CONDITIONAL LETTER OF NO OBJECTION

**RE: REQUEST FOR ENCROACHMENT ACROSS THE NEW BRAUNFELS – AUSTIN LONE STAR
SOUH TEXAS-TX150 – LID: 177 – DB: 21254
LETTER OF NO OBJECTION – COMAL COUNTY, TEXAS**

MAYFAIR - PARCEL E-8 UNIT 2
NEW BRAUNFELS, TEXAS
SANITARY SEWER LINE A - PLAN & PROFILE
STA. 8+50.00 TO 13+50.00

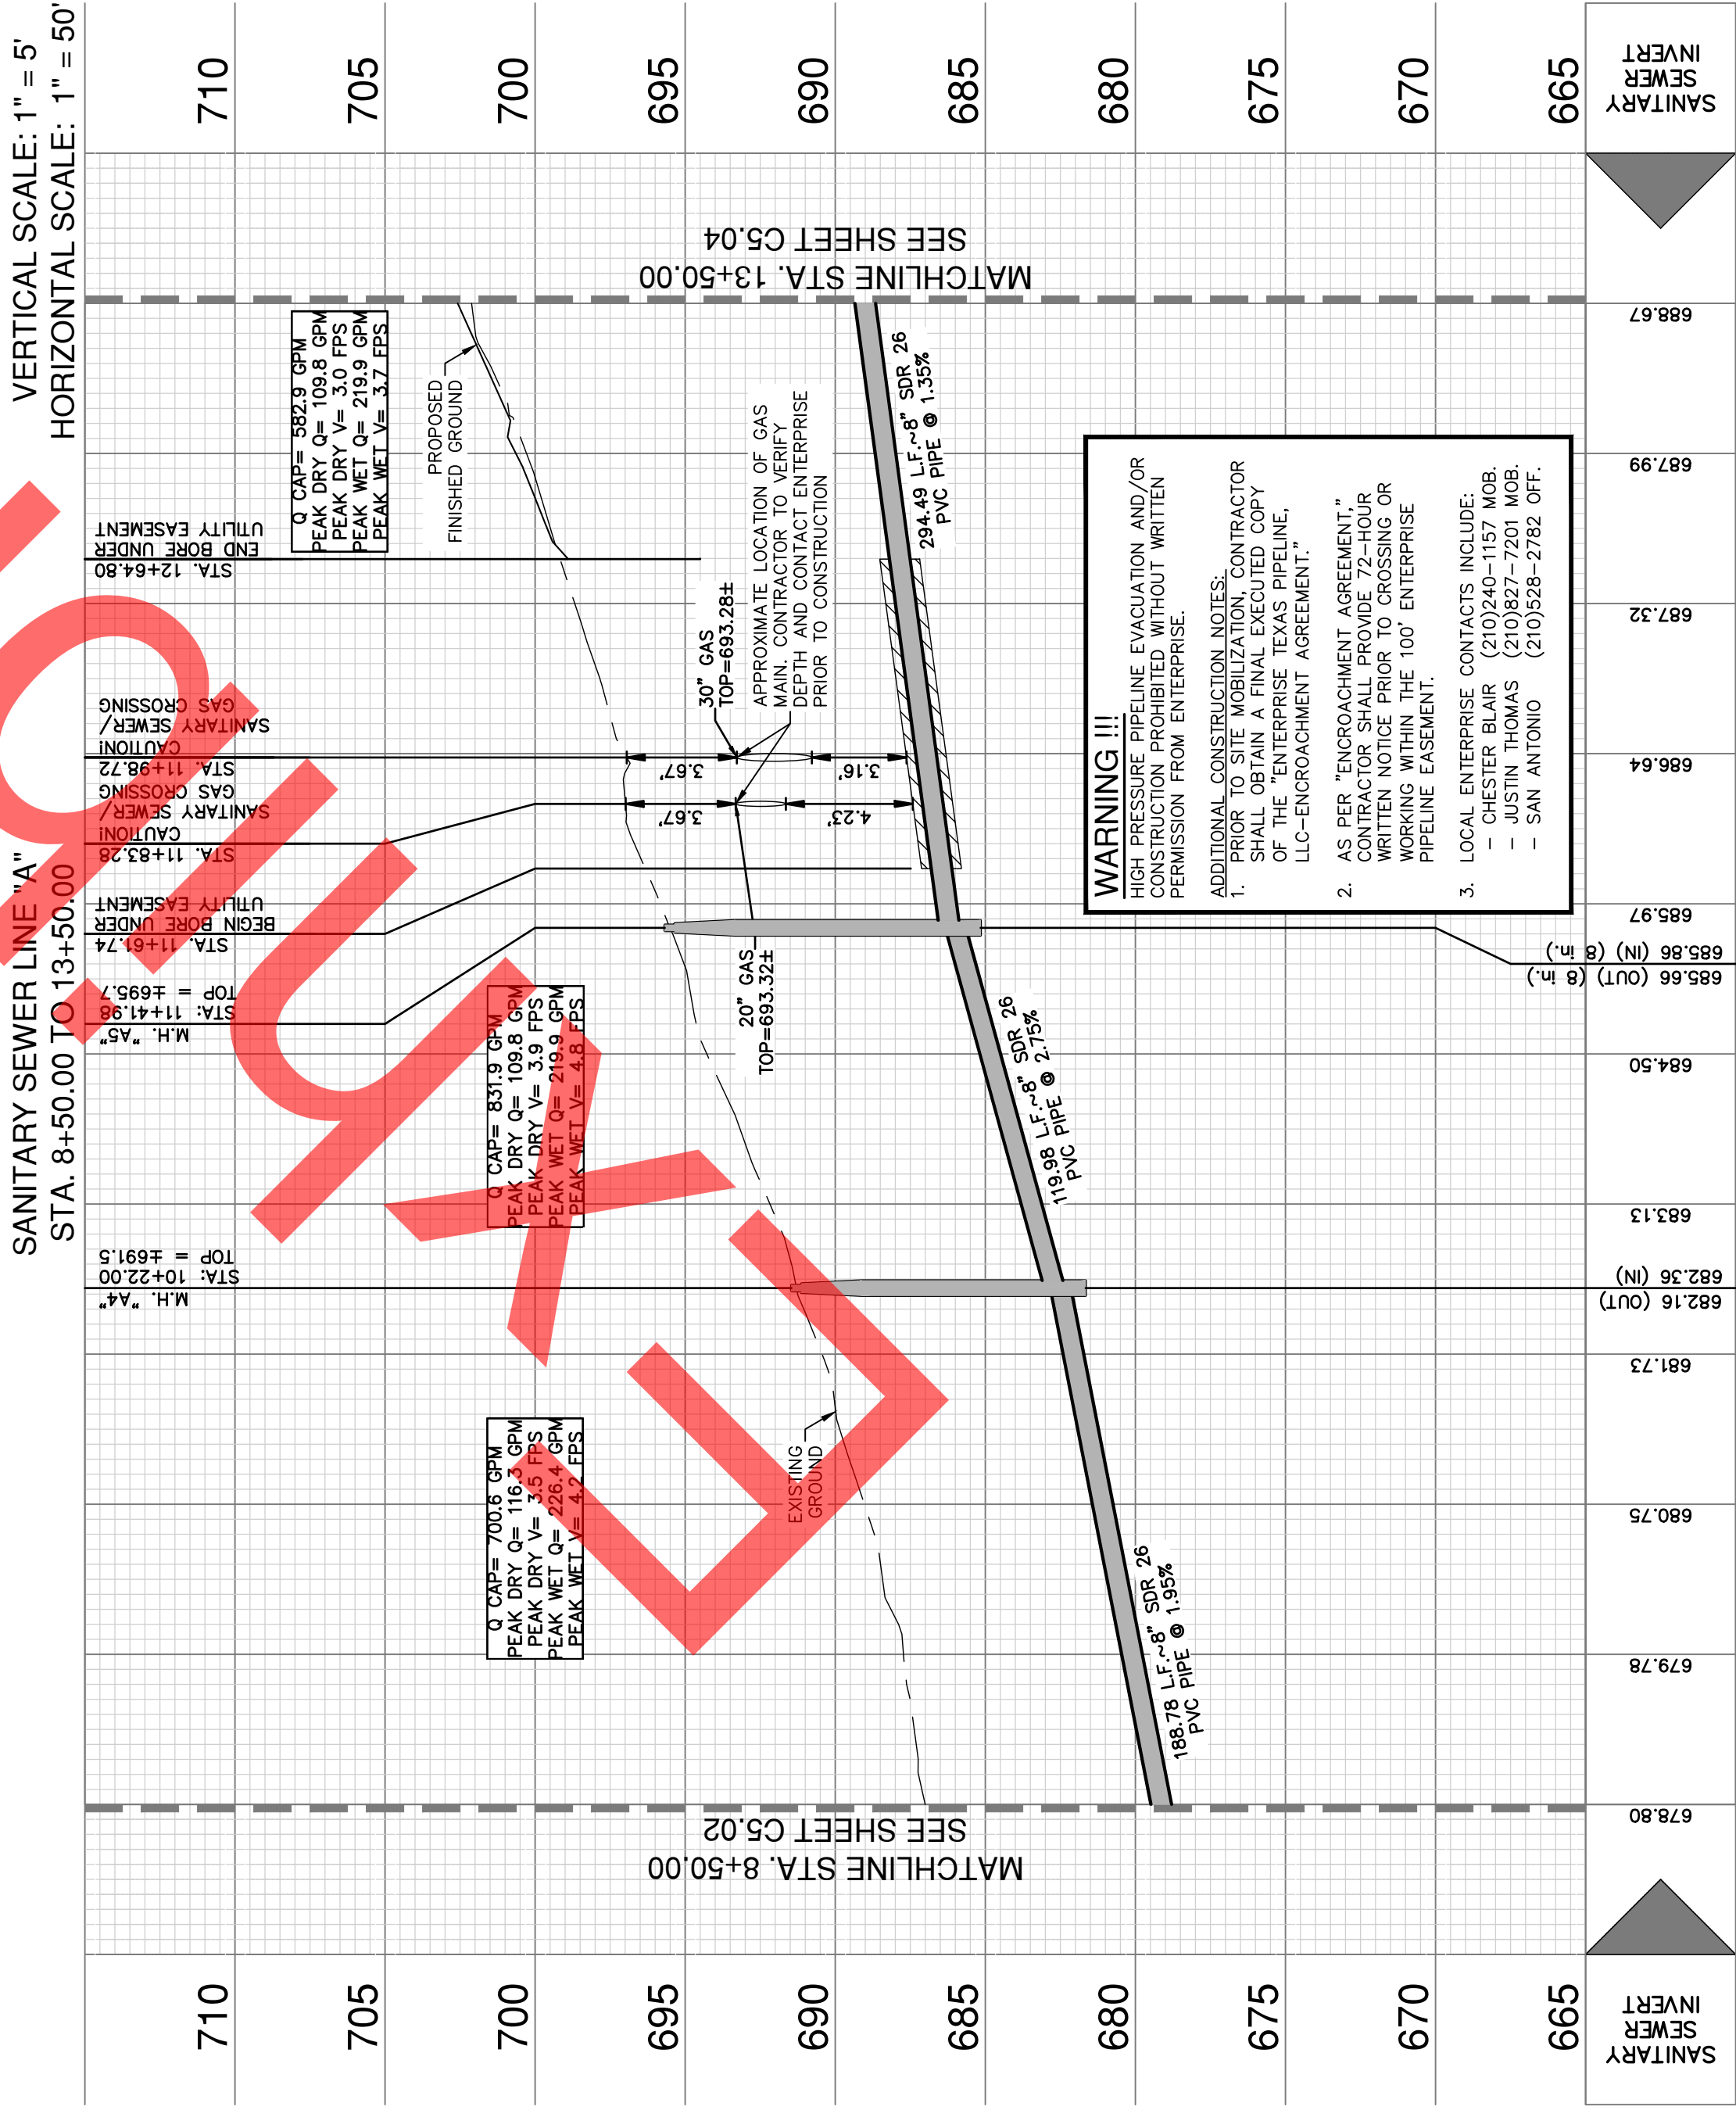
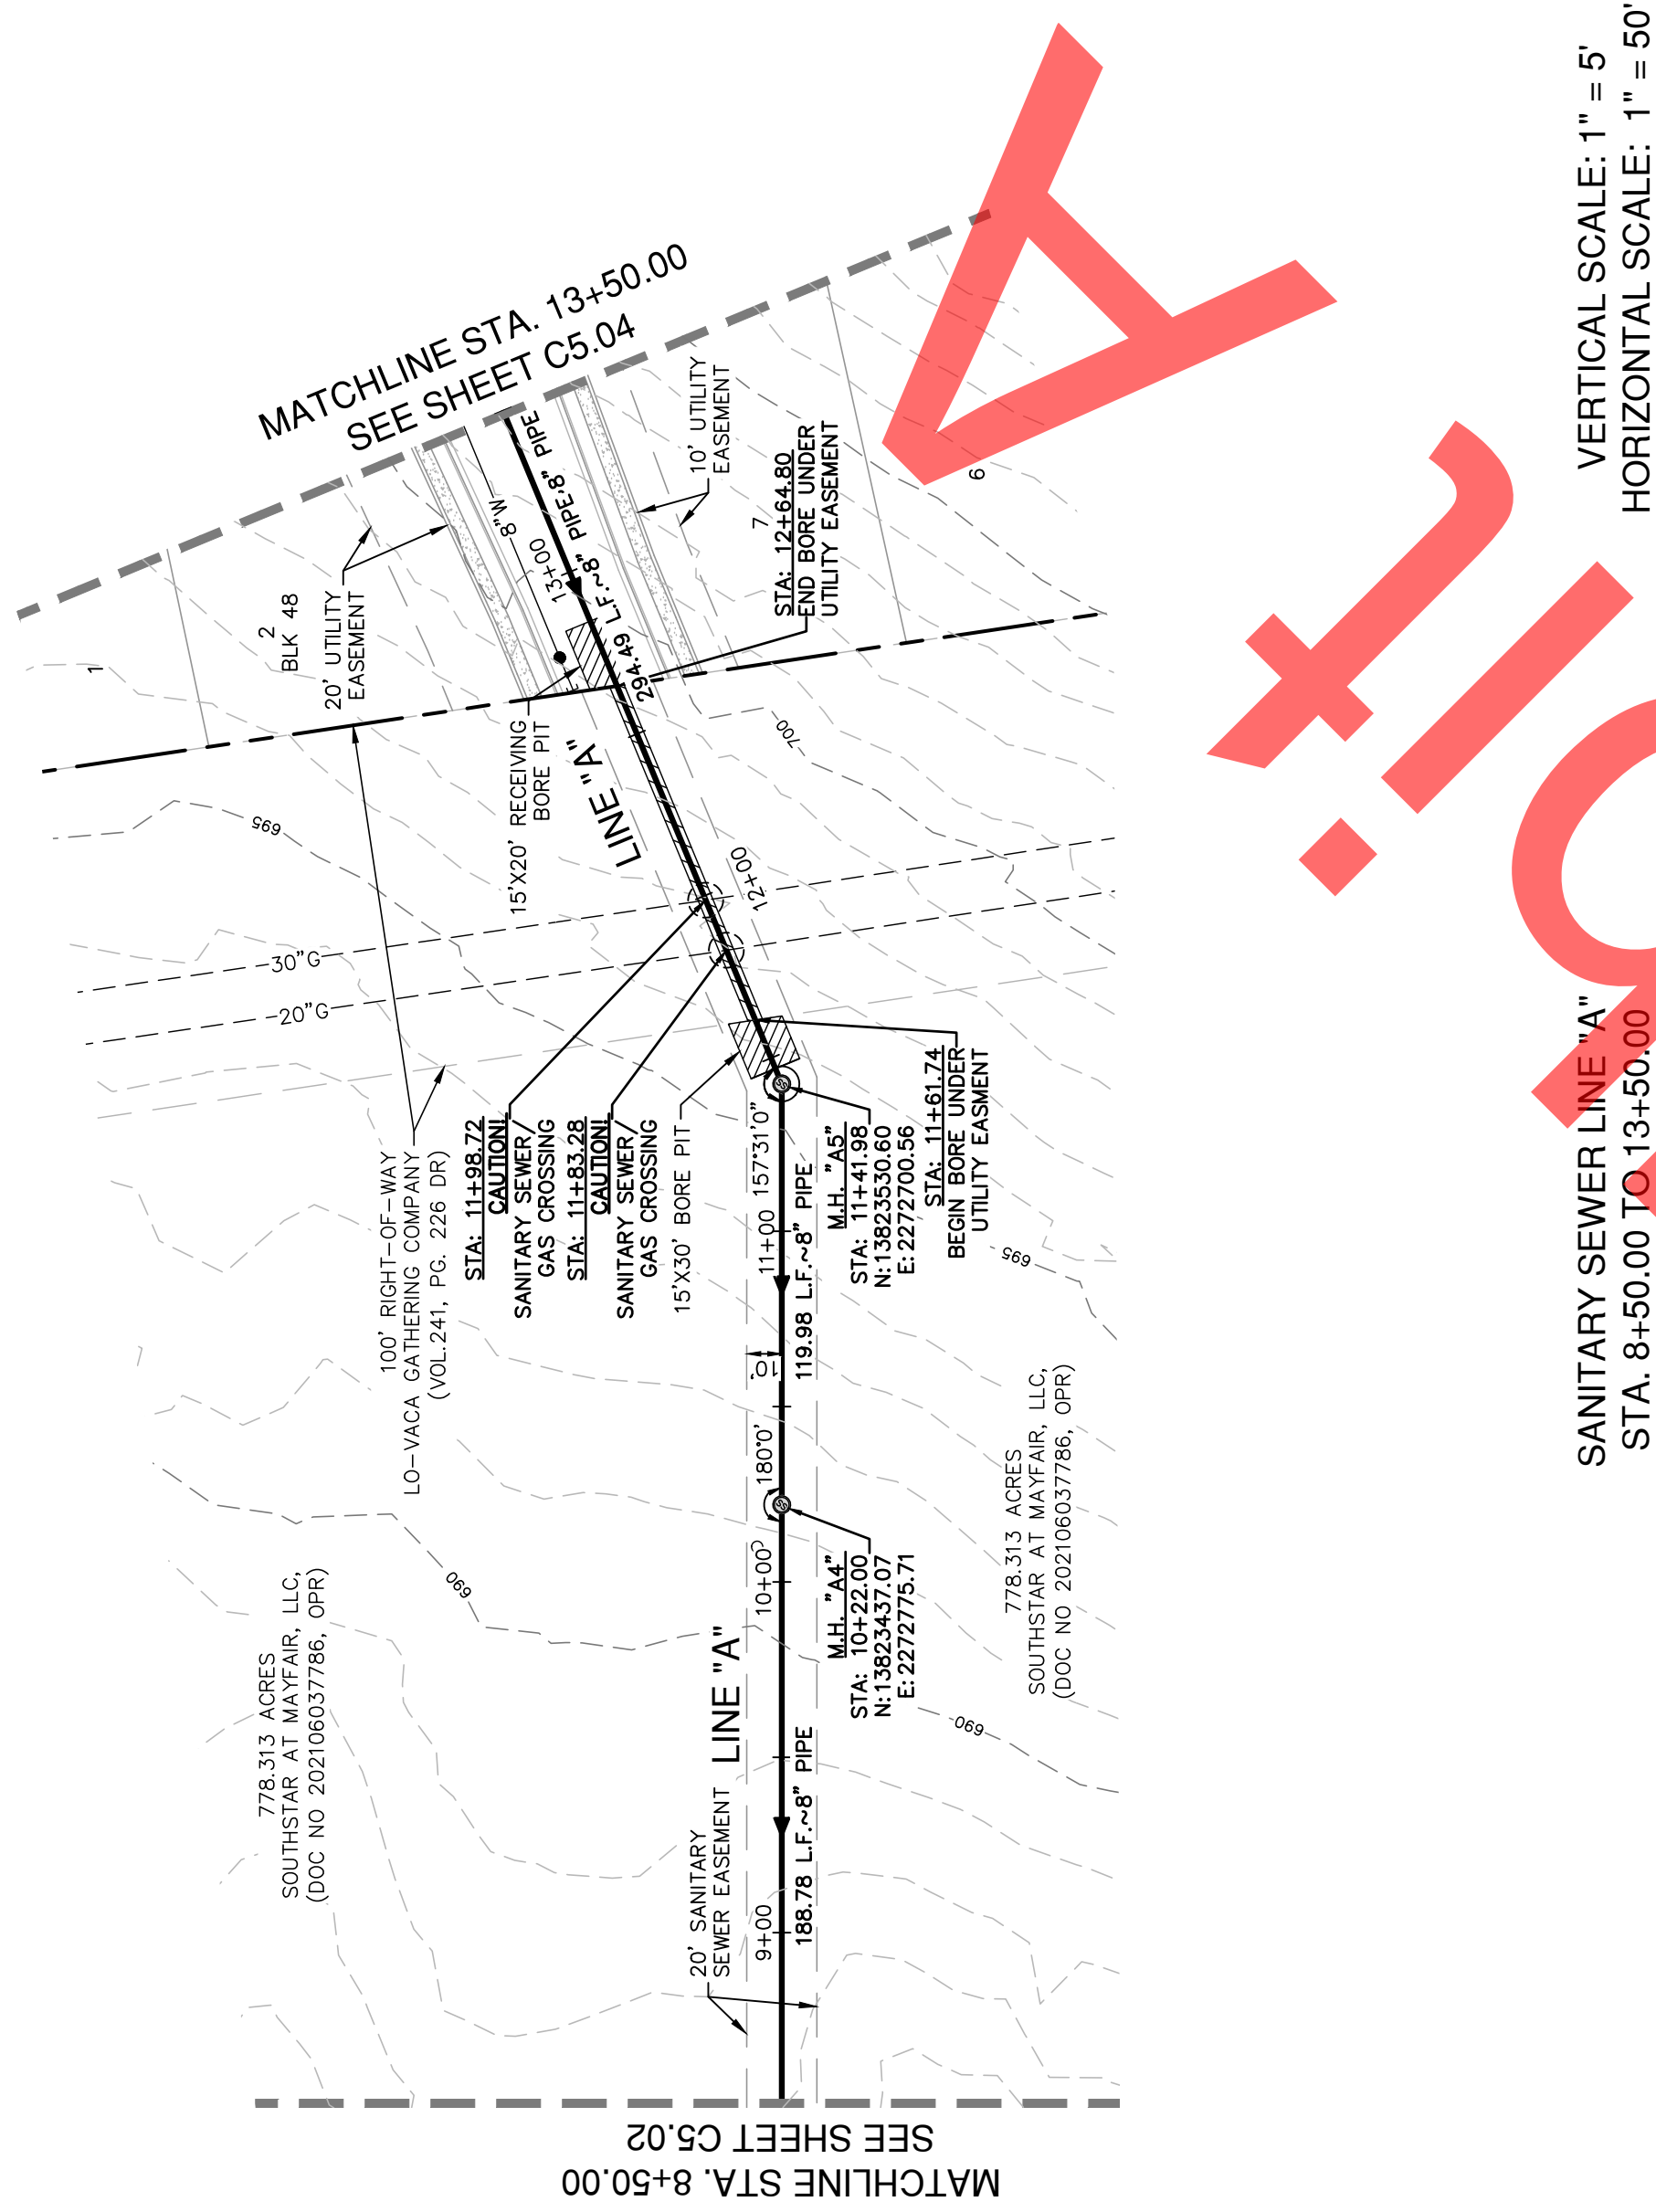
3. The following language must be conspicuously displayed on all drawings depicting the PIPELINE:

WARNING! HIGH PRESSURE PIPELINE

Excavation and/or Construction Prohibited without Prior Written Permission From
Enterprise Products Operating LLC

4. ENTITY'S crossing(s) will be as close to ninety (90) degrees as possible to the PIPELINE, but not less than forty-five (45) degrees. COMPANY will require physical verification of the PIPELINE depth of cover and alignment, at ENTITY'S expense, prior to work being performed near the PIPELINE. Physical verification may be via hydro-excavation or any other method and shall be coordinated with and approved by COMPANY'S REPRESENTATIVE. If the PIPELINE is not at the anticipated alignment or depth, ENTITY shall adjust accordingly at no expense to COMPANY or its affiliates.

5. ENTITY will install the aforementioned one (1) eight inch (8") PVC sanitary sewer across and under the PIPELINE, via trenchless construction, in such a way that a minimum vertical separation of 3.16 feet between the bottom of the PIPELINE and the top of ENTITY'S sanitary sewer is maintained. All bore pits should be outside the EASEMENT. ENTITY shall include adequate inspection potholes a minimum twenty-four inches (24") below the PIPELINE to ensure pilot drill is below the PIPELINE. Location of inspection potholes is at the discretion of the COMPANY'S REPRESENTATIVE. ENTITY shall install foreign utility post markers at the EASEMENT edges if the utility line installed crosses below the PIPELINE with less than four feet (4') of vertical separation from the outer edge of the PIPELINE. ENTITY should evaluate the stipulations provided and adjust accordingly at no expense to COMPANY, or its affiliates, if the stipulations provided present safety and/or environmental concerns.
